# ROOSEVELT ASSEMBLAGE

PROPERTY ADDRESS  
6716 Roosevelt Way NE, Seattle WA

# 8.0 ITEMIZED RESPONSE TO EDG

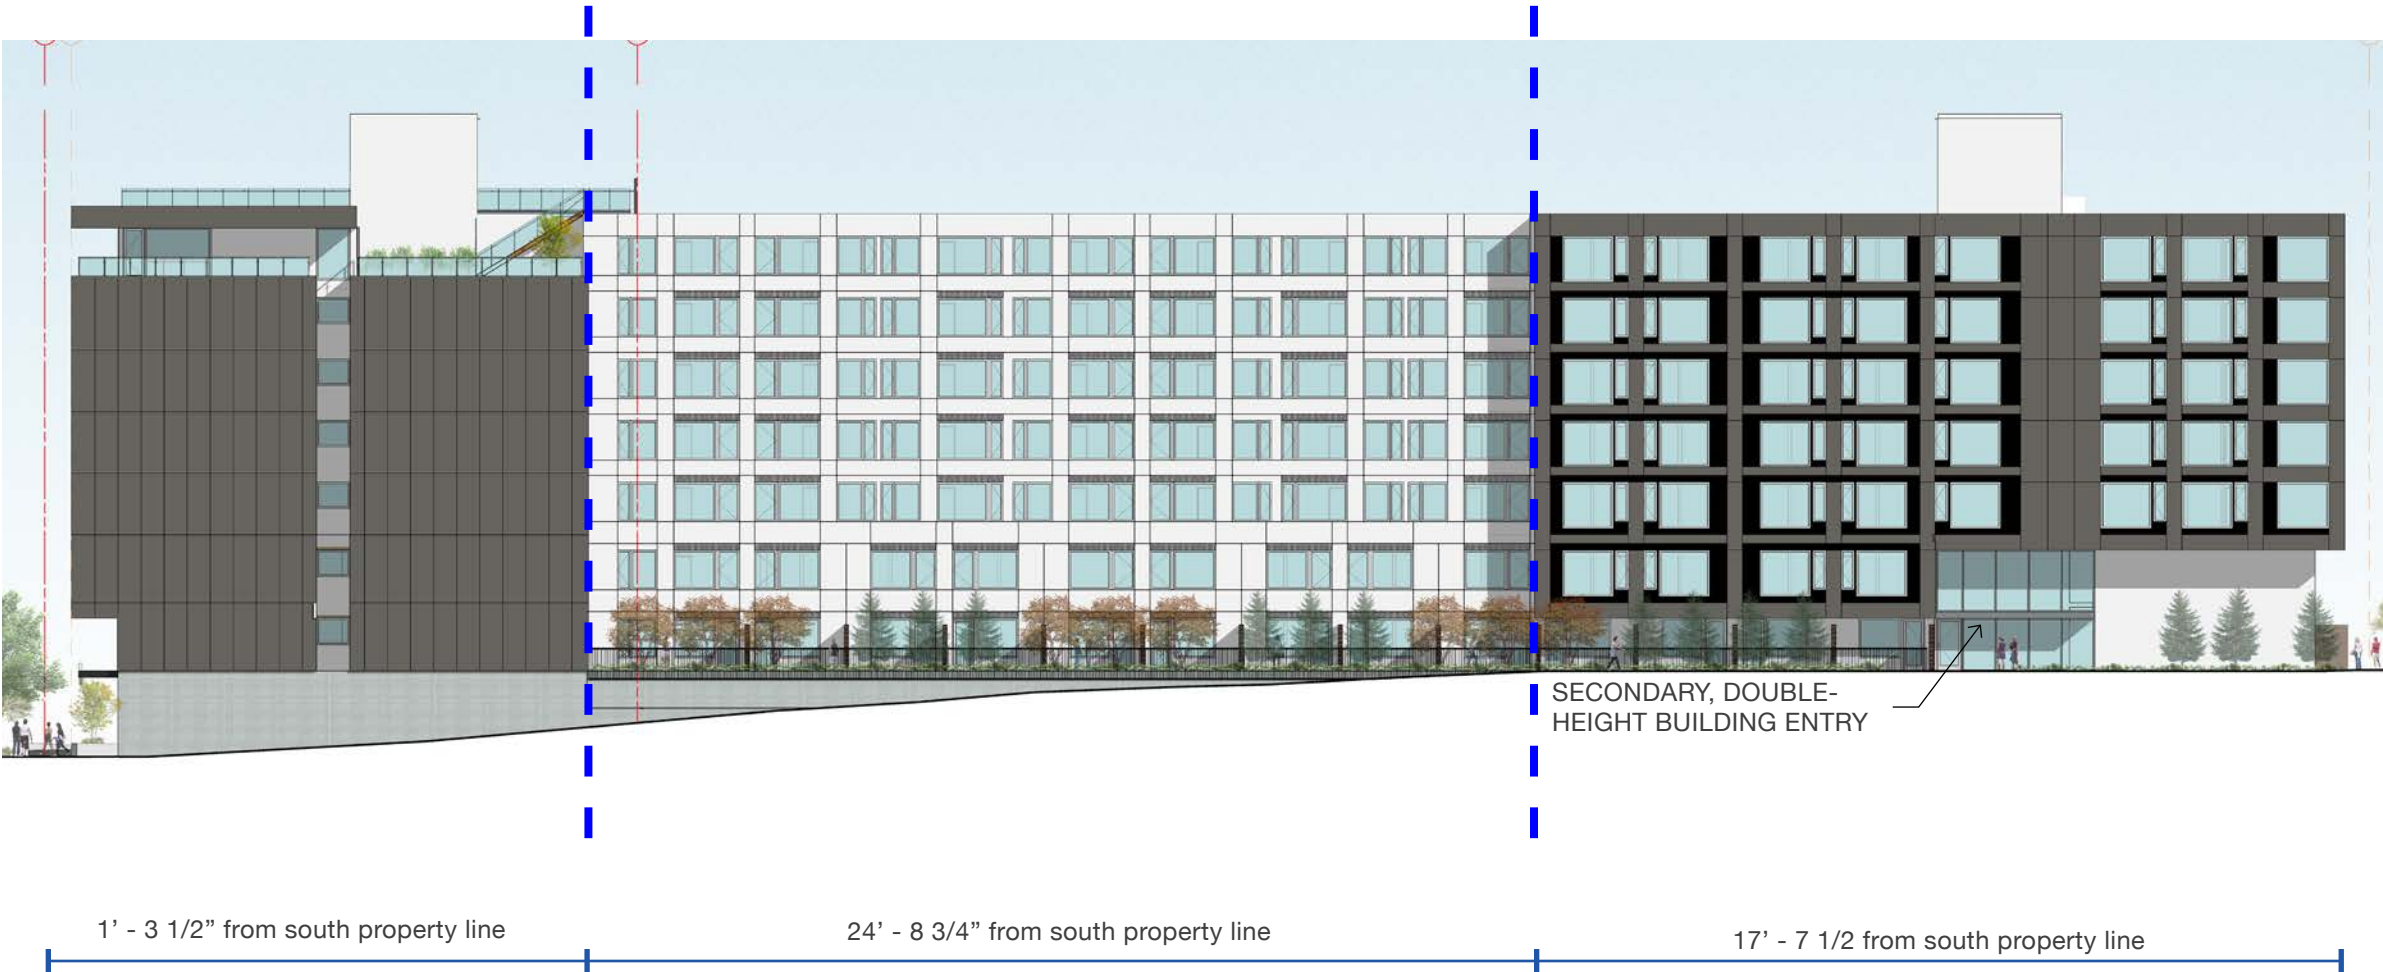
**2b** *b) The Board noted that very little information was provided in the EDG packet or presentation about the proposed massing or articulation on the south side of the building. Moving forward, the Board requested that the applicant apply the same rigor and attention to the massing and articulation of the south side as was given the north. CS2-C-1, CS2-C-3, CS2-D-5, CS2-III-iii, CS2-III-iv, DC2-A*

The design of the south facade is cohesive yet organized into three distinct portions. The eastern “third” relates to 12th Avenue, as the overhanging gray and black mass wraps the corner and steps down just beyond the secondary lobby entry, subtly emphasizing it.

The western “third,” in the NC zone, holds the Roosevelt street edge and therefore sits close to the property line. The gray and black materiality also wraps here from the west.

The central “third” is in the recessed plane of the lower floors as they wrap from the east, and therefore maintains the white stucco expression of these lower floors. Ground level units are provided with private decks which overlook planted areas within the rear setback area of the MR zone.

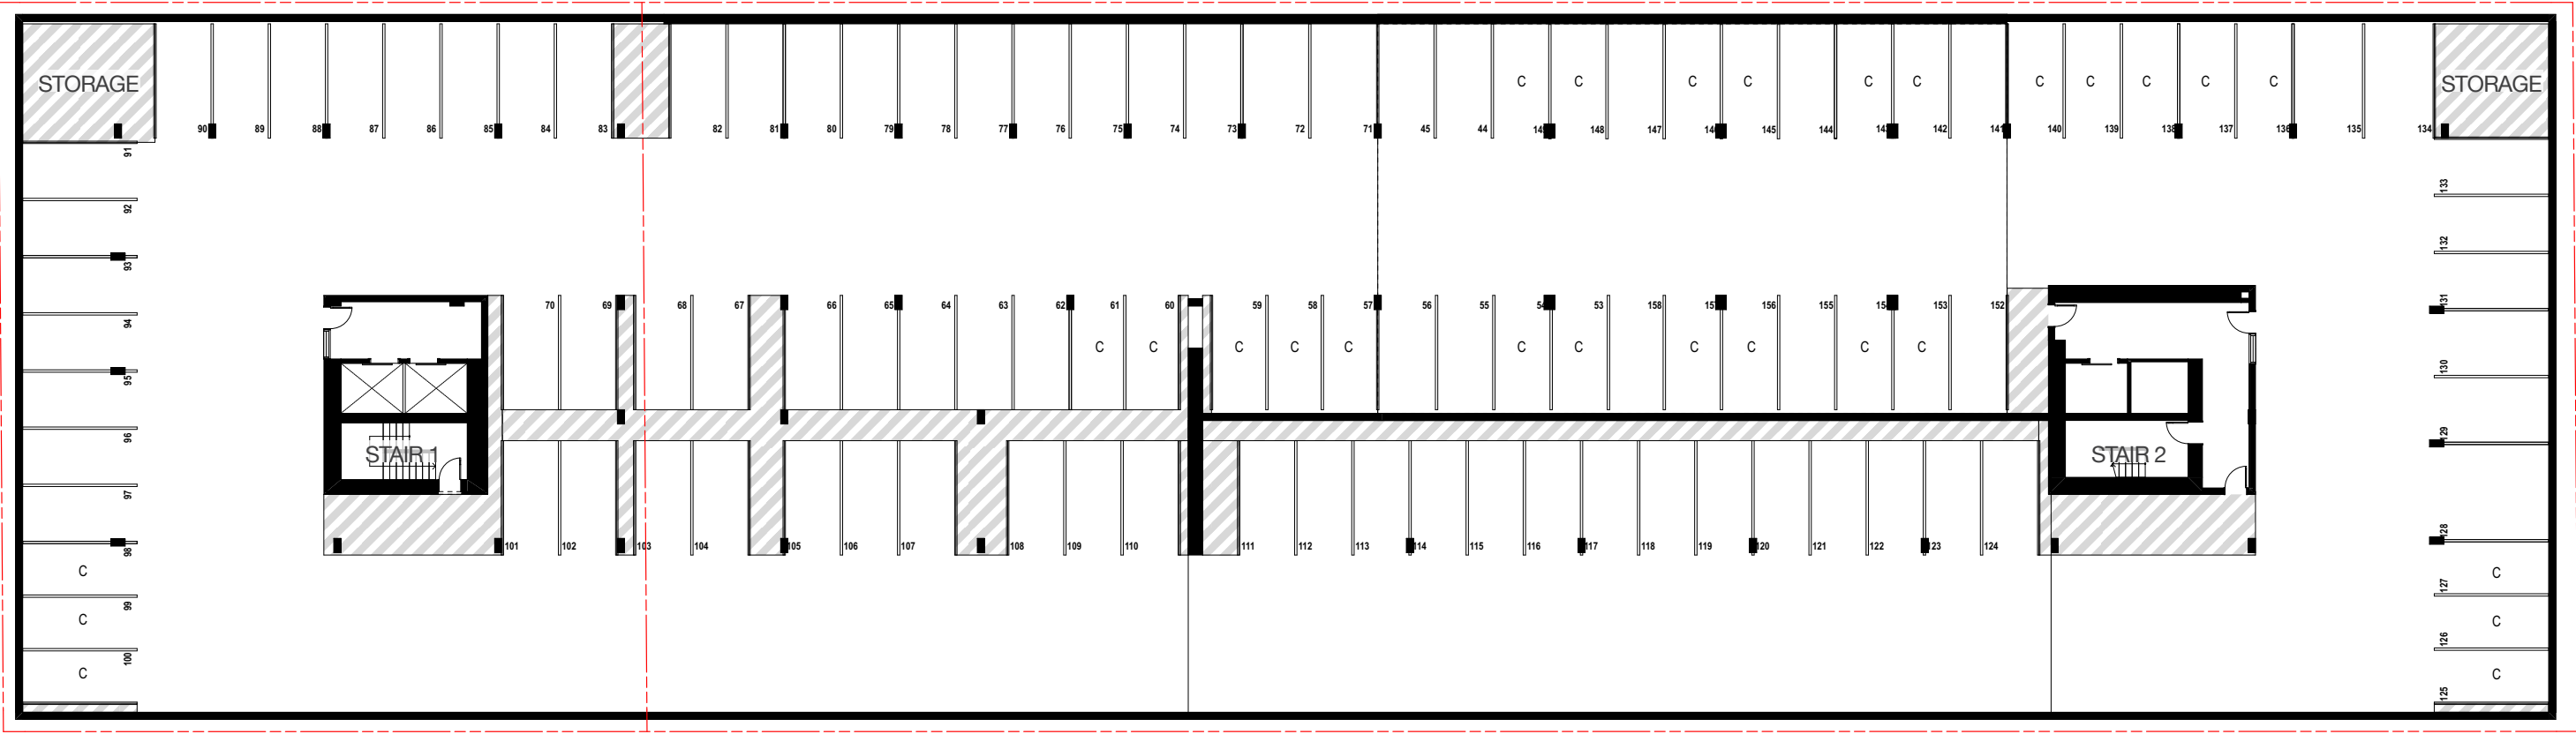
**4d** d)The Board noted that there was little information provided in the EDG packet showing bike access and storage or the solid waste storage and staging approach. Provide this information at Recommendation. PL4-B, DC1-C-4

**Response:**  
Long term bike storage is provided in the parking garage. From 68th St, bicyclists can enter through a man door and walk along the garage ramp, or from Roosevelt Way NE bicyclists can enter through the door at the south and reach the parking garage through a ramped corridor.

Solid waste storage is also proposed in the parking garage and is proposed to be staged in a parking strip along 68th St, just west of the parking entry. The dumpsters will be moved to the staging area by building management. This staging area was chosen in order to not be directly in front of ground level residential units.

SDOT has approved the proposed location.
